Addendum #01

Client	Indiana University	Date	05/26/26
Project	BL059 IU Lindley Hall – Replace Existing Windows	Champlin Project #	639-8160
		Client Project #	20250516

A201

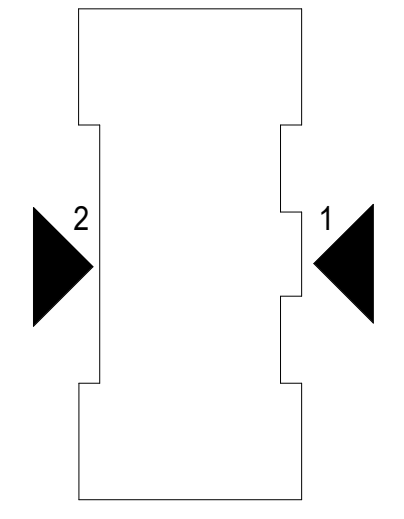
7. QUESTION: Does the owner want frosted glazing in the restrooms?
RESPONSE: Yes, provide integral frosted glass at the restrooms. A201 attached shows the windows in "red" that will require frosted glass.
